Seabrook Station

Request for Review and Approval of License Amendment Request (LAR) 11-04, Changes to
Technical Specifications for New and Spent Fuel Storage, in Two Parts

Markup of the TS for Spent Fuel Storage Portion of LAR 11-04

Figure 3.9-1
Fuel Assembly Burnup vs. Initial Enrichment
For Spent Fuel Assembly Storage

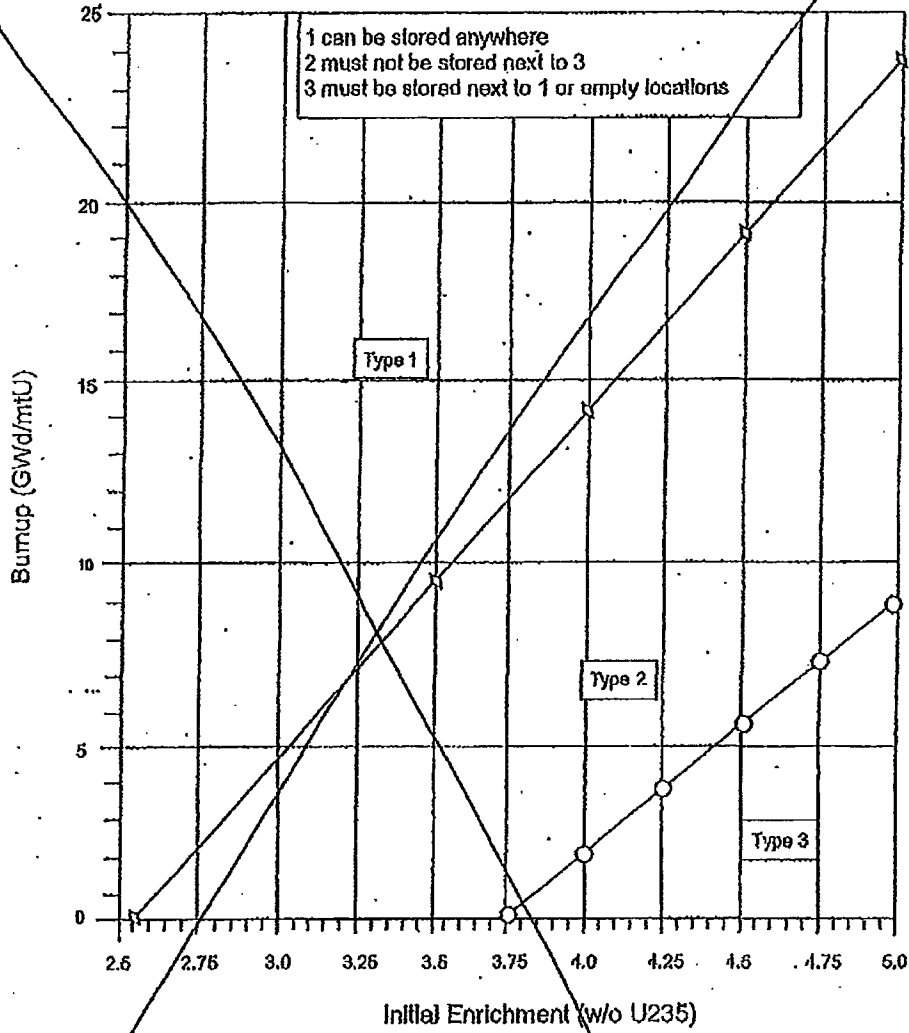
3.9.13 Fuel assemblies stored in the Spent Fuel Pool shall be placed in the spent fuel storage racks according to the criteria shown in Figure 3.9-1 ← Specification 5.6.1.3

- a. With the requirements of the above specification not ^{insert immediately} satisfied, suspend all other fuel movement within the Spent Fuel Pool and move the non-complying fuel assemblies to allowable locations in the Spent Fuel Pool in accordance with Figure 3.9-1 ← Specification 5.6.1.3.
- b. The provisions of Specification 3.0.3 are not applicable.

4.9.13.2 After fuel assembly(ies) movement into or within the Spent Fuel Pool, the position of the fuel assembly(ies) that was (were) moved shall be checked and independently verified to be in accordance with the criteria in Figure 3.9-1

DELETE

4.9.13.1 Prior to fuel assembly movement into or within the Spent Fuel Pool, verify by administrative means that the requirements of Specification 5.6.1.3 are satisfied.

5.6.1.3 Fresh or irradiated fuel assemblies shall be stored in the spent fuel pool in compliance with the following:

Figure 5.6-1

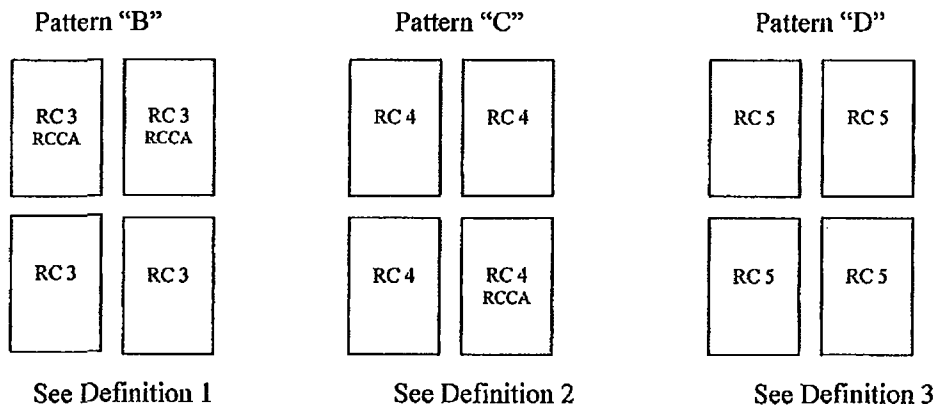
INSERT ATTACHED
Table 5.6-1
Table 5.6-2
Figure 5.6-1
Figure 5.6-2

- a. Any 2x2 array of Region 1 storage cells containing fuel shall comply with the storage pattern in Figure 5.6-1 and the requirements of Table 5.6-1. The reactivity ranks of fuel assemblies in the 2x2 array (rank determined using Table 5.6-1) shall be equal to or less than defined for the 2x2 array.

1. Allowable pattern is fuel assemblies that meet Reactivity Class (RC) 1, 2, 3, 4, or 5 checkerboarded with fuel assemblies that meet RC 2, 3, 4, 5. Requirements for all RC are defined in Table 5.6-1. Diagram is for illustration only.

1. There are no interface limitations within Region 1 between rack modules or within racks. Each cell is a part of up to four 2x2 arrays, and each cell must simultaneously meet the requirements of all those arrays of which it is a part.
2. Replacement of any fuel assembly by an empty water hole, non-fuel hardware or fuel rod storage basket is acceptable.
